MEMORANDUM

Subject: **RZ 15-021:** Pursuant to the City of Dunwoody Zoning Ordinance, §27-330, applicant, Cypress Communities, LLC, on behalf of CQ Dunwoody Village Court, LLC, seeks permission to rezone property currently zoned Office-Institution (O-I) District to Multi-dwelling Residential District (RM-100) to allow for construction of an 81-unit townhome development. The subject property consists of two parcels: tax parcel 18-366-060-61 located at 1530 Dunwoody Village Parkway, Dunwoody, GA 30338, and tax parcel 18-366-060-65 located at 1536 Dunwoody Village Parkway, Dunwoody, GA 30338.

DRAWING NUMBER
C-1

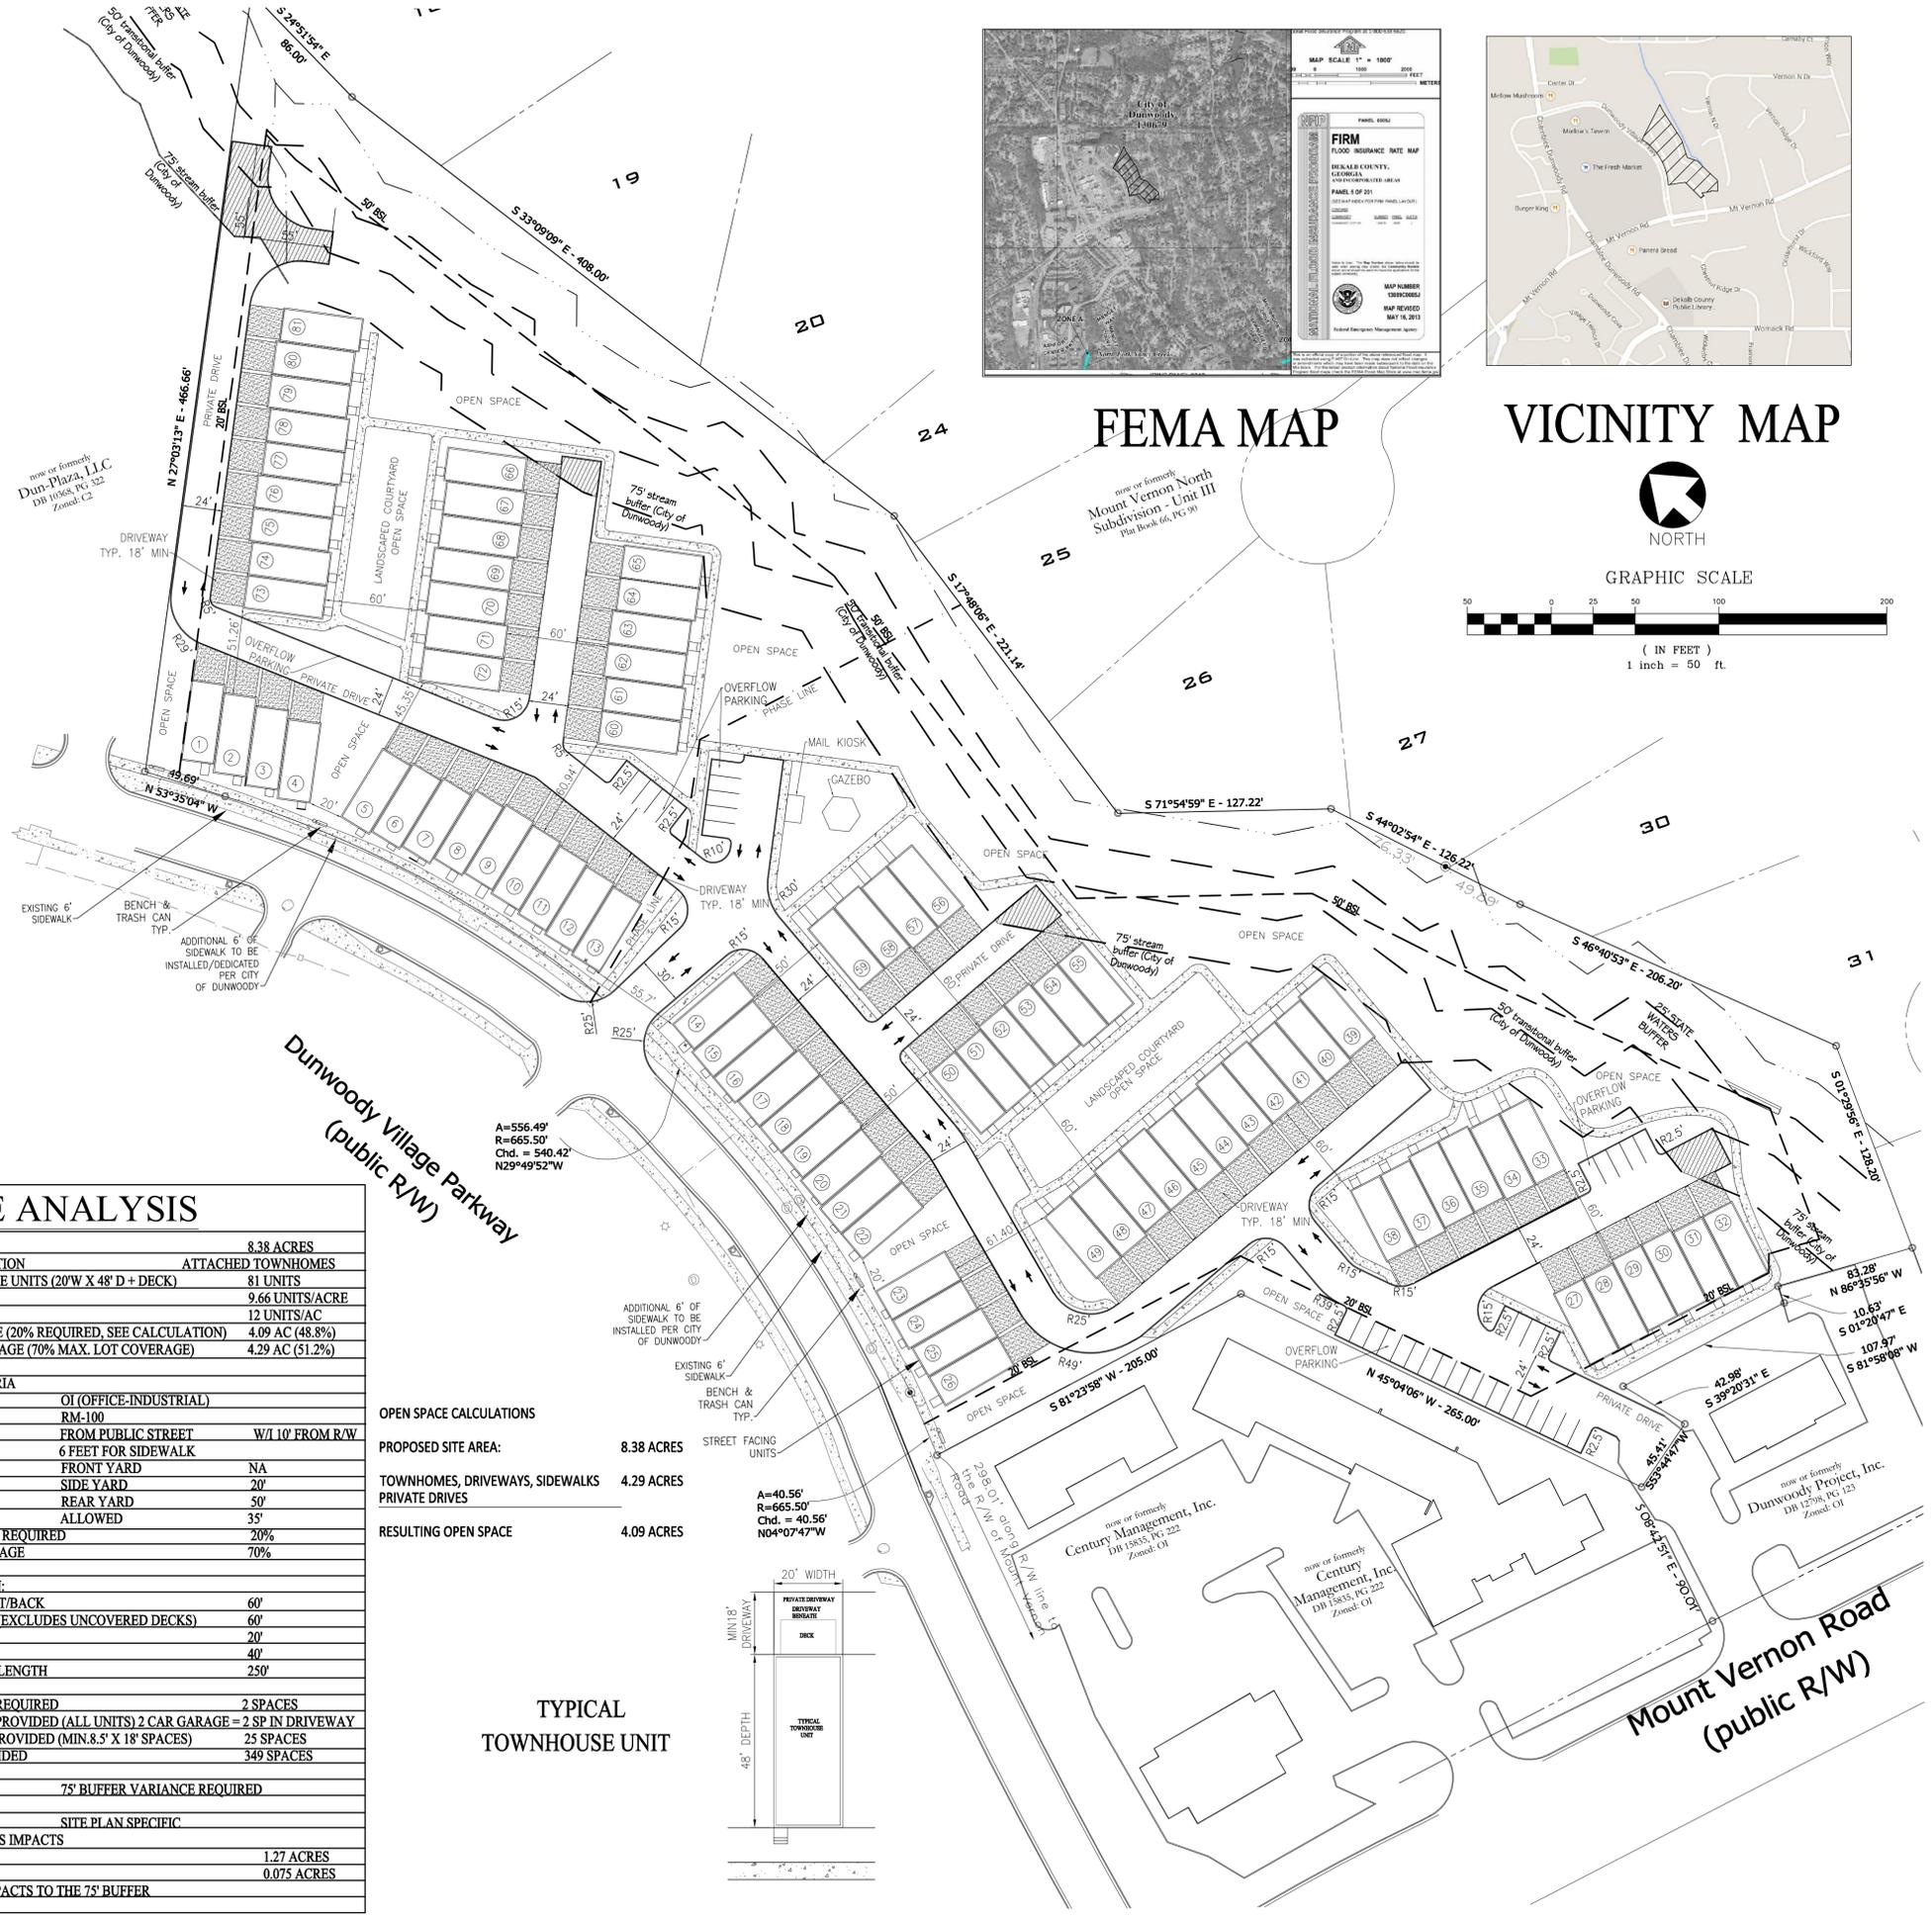
1. An additional sidewalk has been added per staff's request adjacent to Unit 72; however, it is located against the townhouse and narrows down severely to navigate around the unit.
2. A phasing line has been added left of the main entrance.
3. Guest parking adjacent to the two open spaces has been removed per a comment from a Planning Commission member.
4. The central loop driveway has been altered to create a larger open space and a gazebo provided.
5. Additional parking has been added along the driveway exit toward Mt. Vernon Road that will serve as guest parking and for the use of the adjacent office building.
6. The pedestrian trail note for the adjacent subdivision has been removed (and will be addressed through a condition of approval).

CONCEPT LANDSCAPE/BUFFER
 SCALE: AS SHOWN
 DATE: 05/04/15
 PROJECT: FA-15000
 SHEET
L-1
 SHEET 1 OF 1

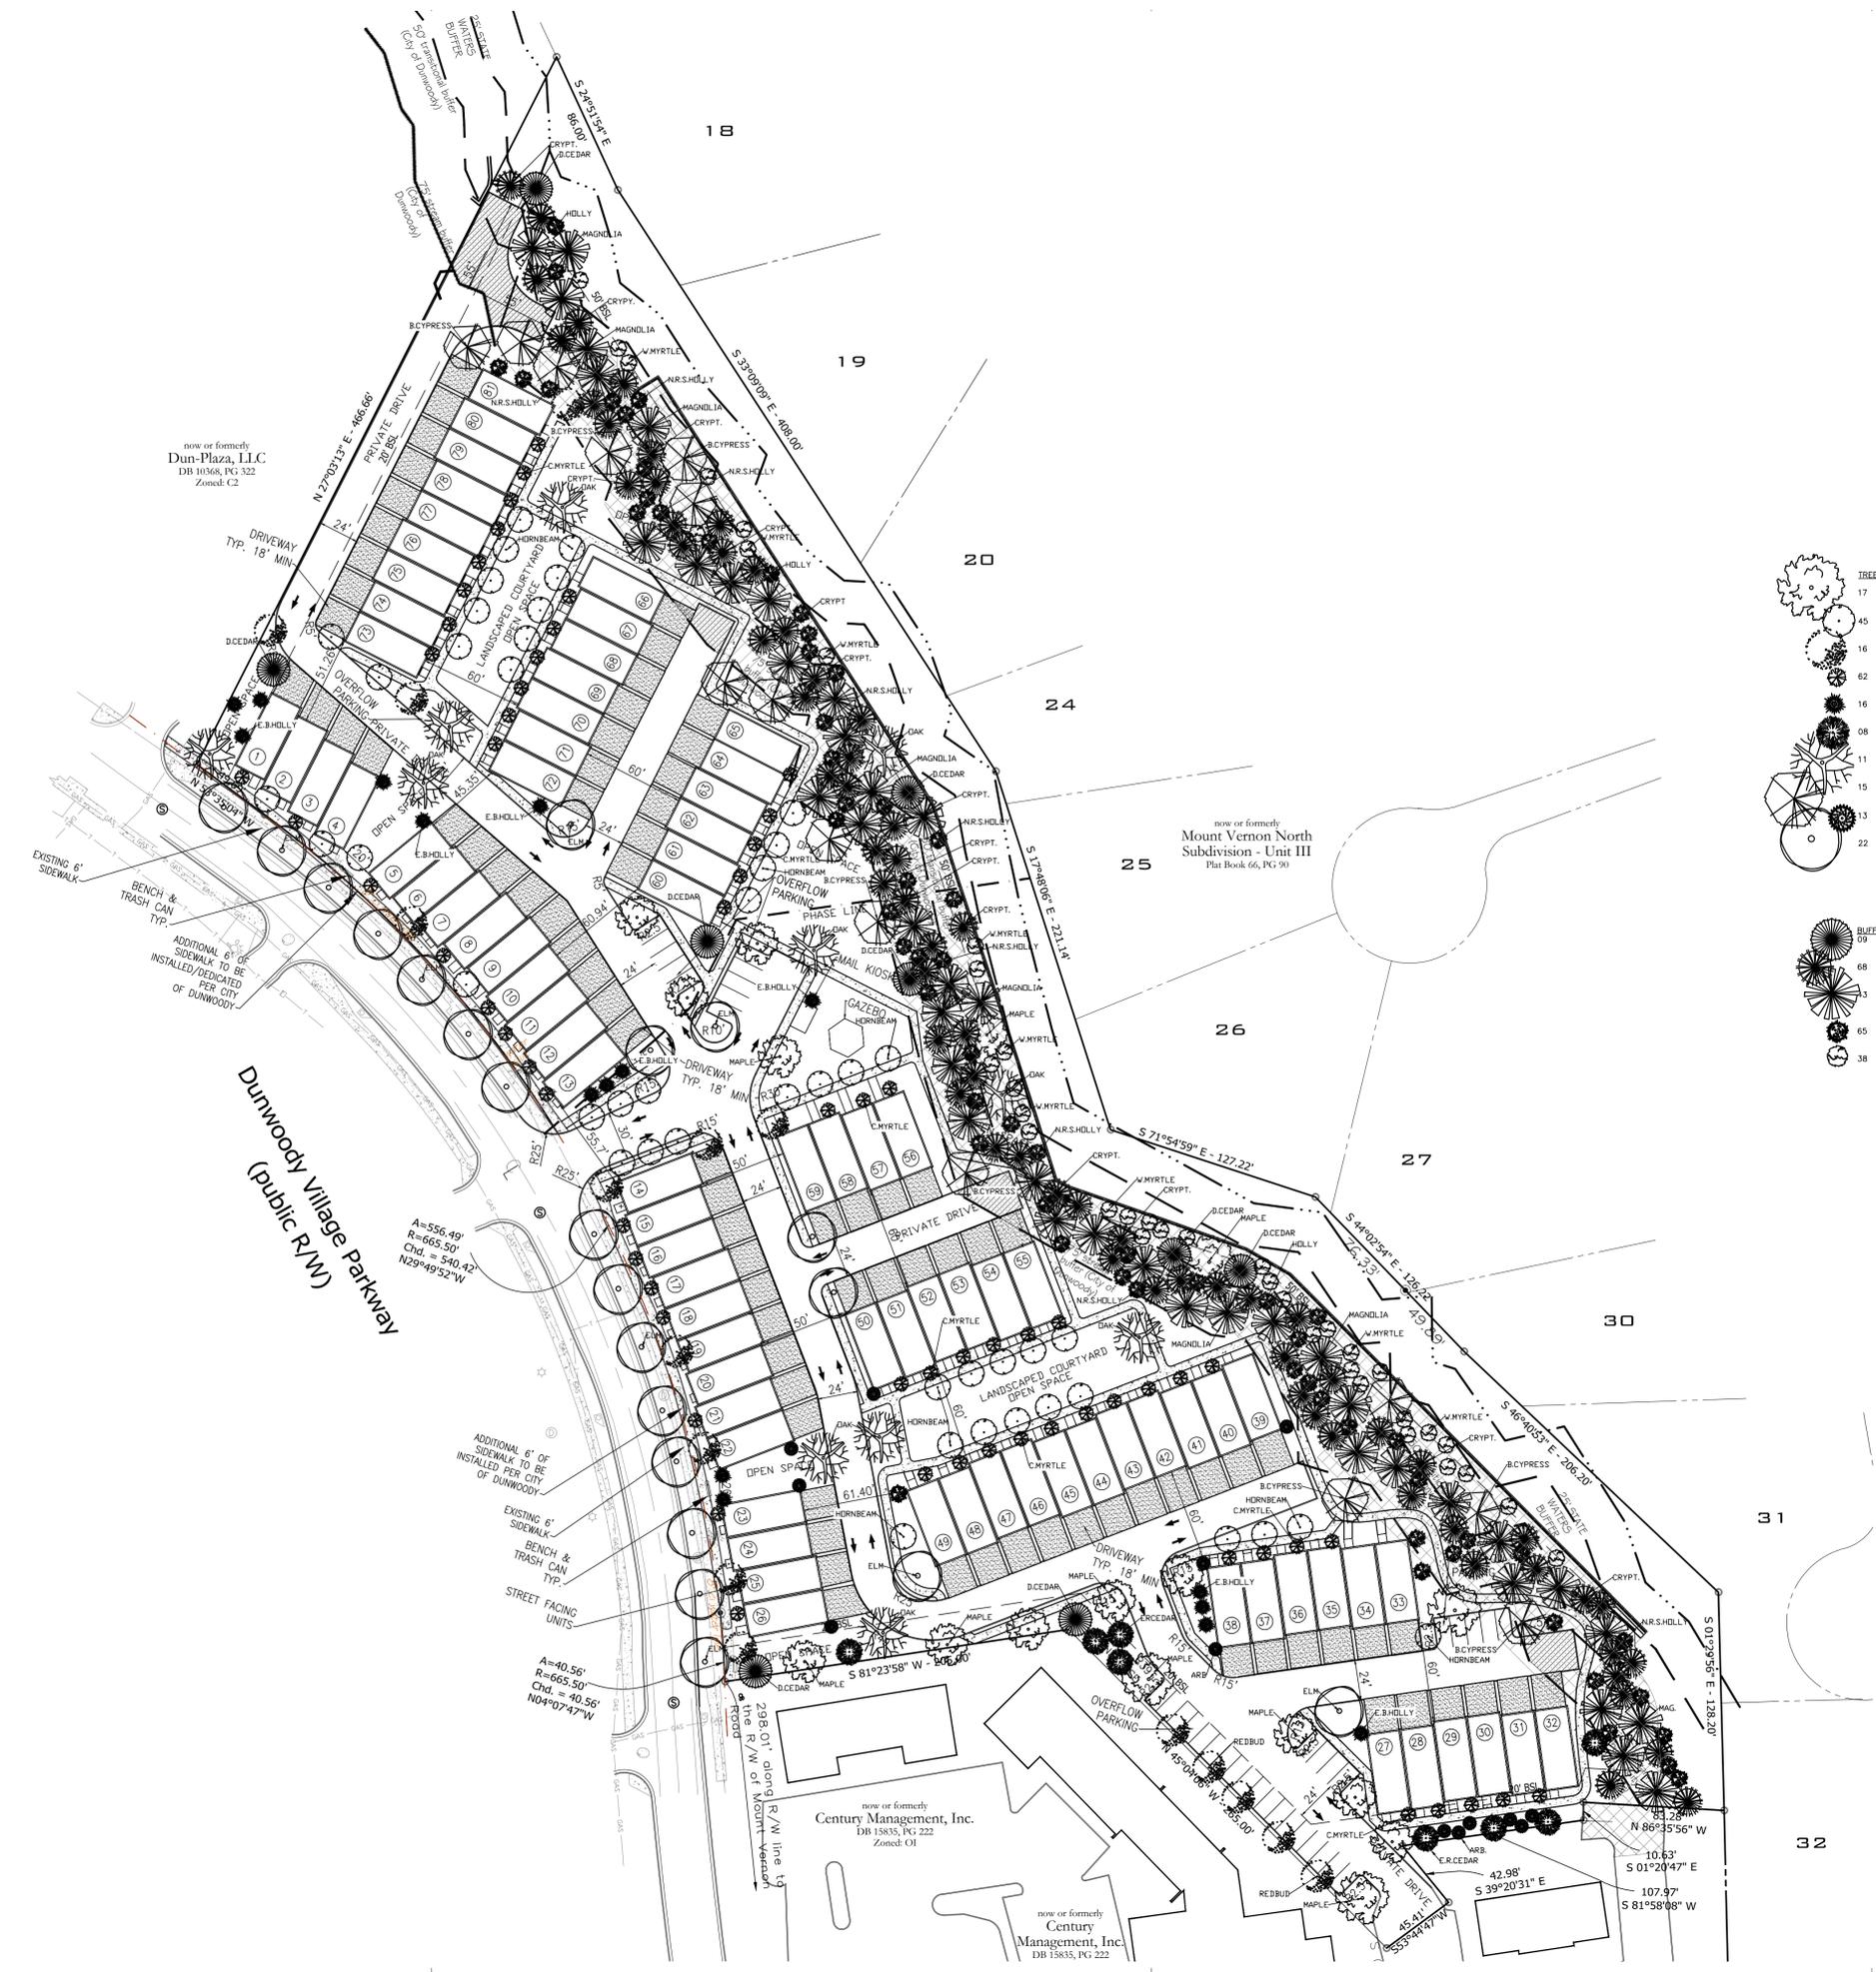
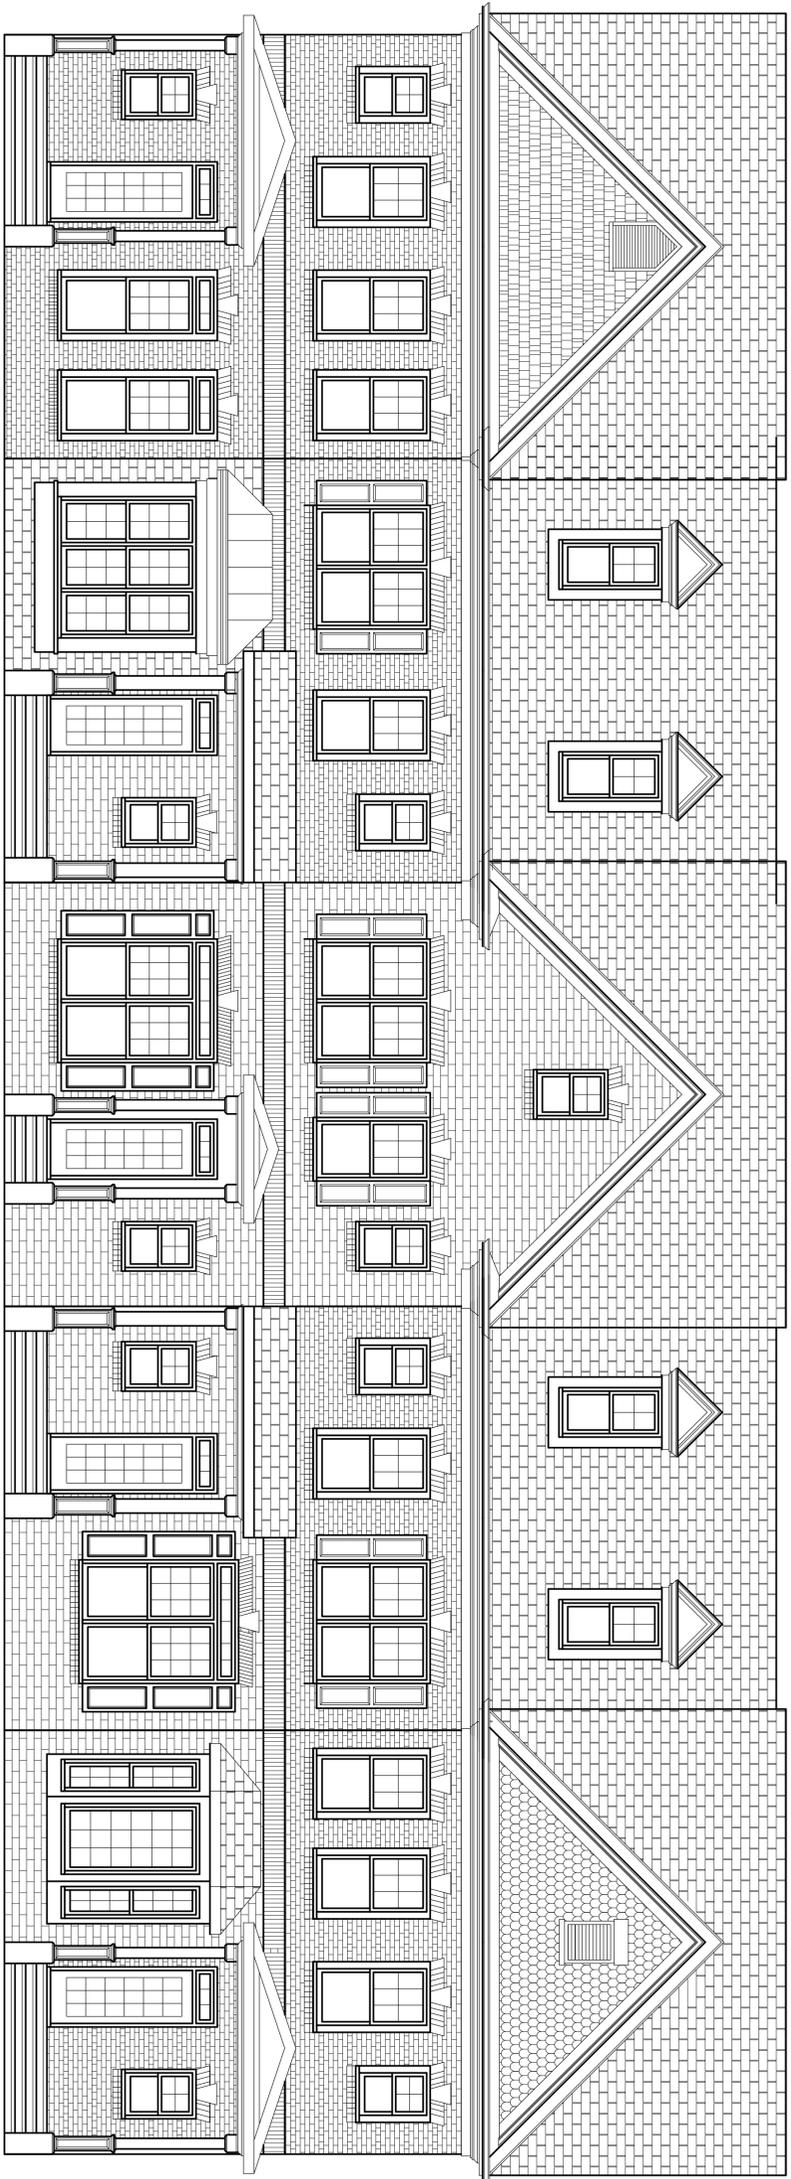
1. Has been modified to match the current site plan layout.
